Docket Number:	08-AFC-08A
Project Title:	Hydrogen Energy Center Application for Certification Amendment
TN #:	200663
Document Title:	HECA PSA-DEIS Workshop Presentation Slides for the 9/17-19, 2013 Workshops in Buttonwillow
Description:	N/A
Filer:	Tiffani Winter
Organization:	California Energy Commission
Submitter Role:	Commission Staff
Submission Date:	9/30/2013 3:33:44 PM
Docketed Date:	9/30/2013

HECA PSA/DEIS

PSA/DEIS - Workshop Purposes

Water Supply PSA/DEIS

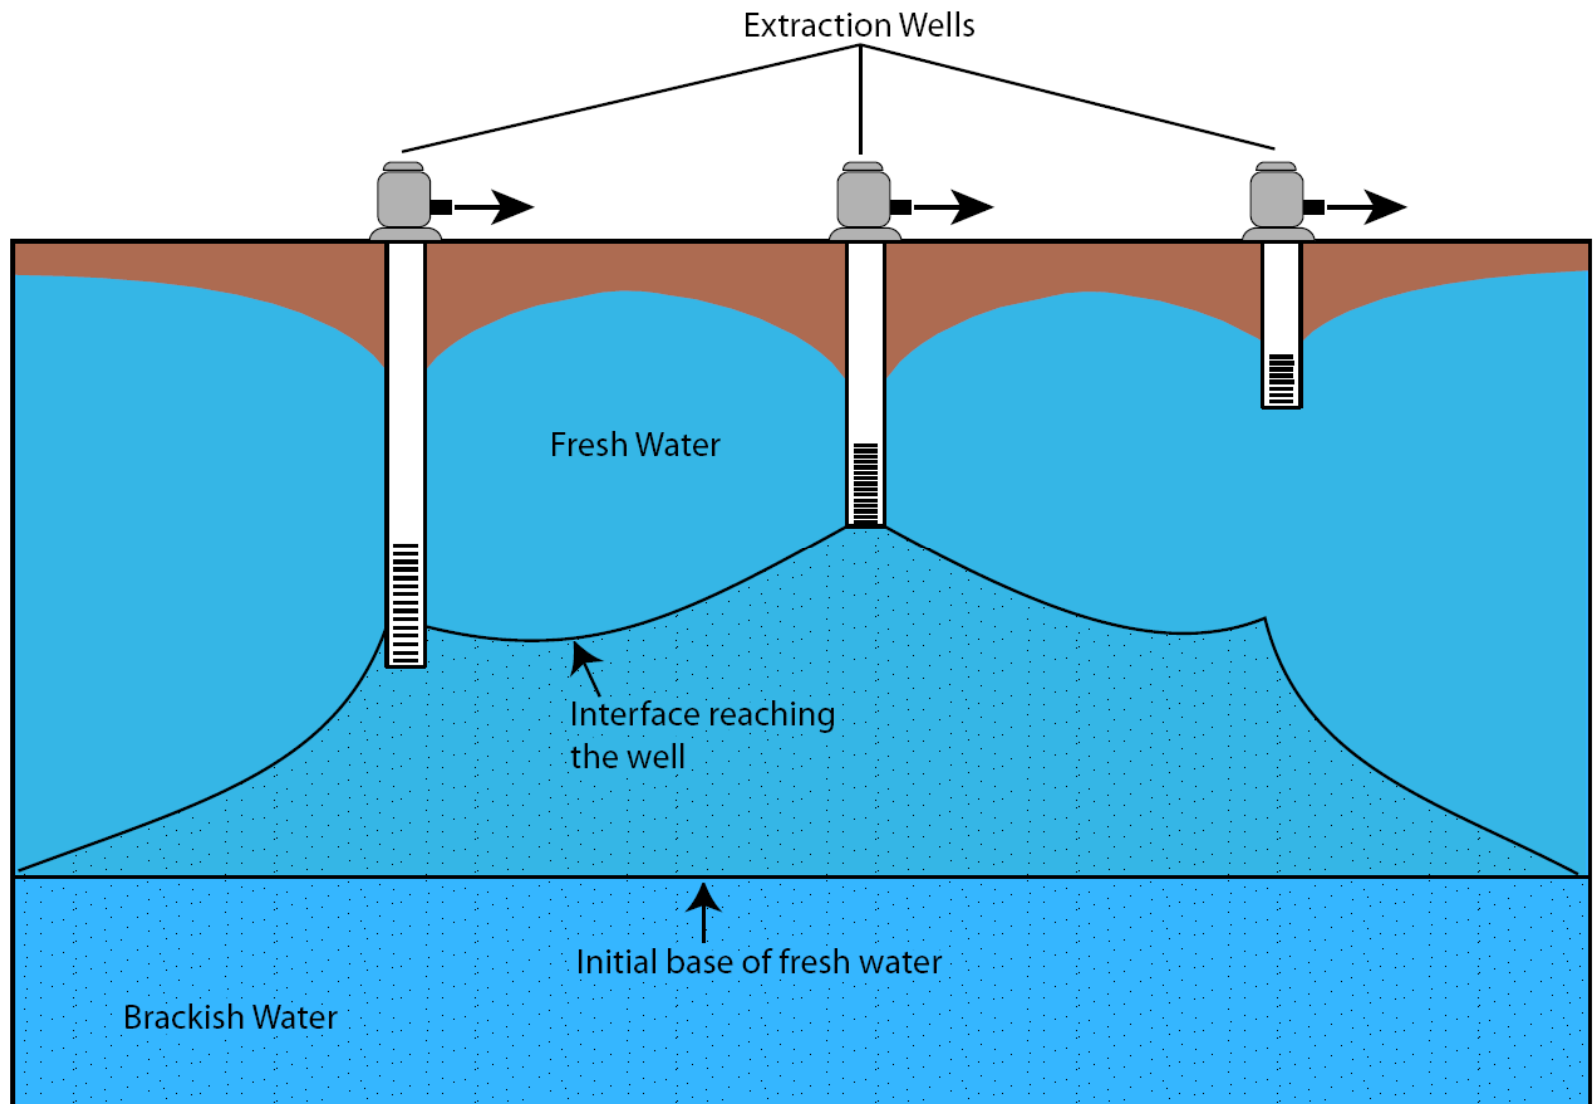
Remaining Issues:

- ❖ How can project ensure use of poor water?
- ❖ Can project minimize water use?
- ❖ What mitigation is available for overdraft?
- ❖ Can any alternative water supplies be considered?
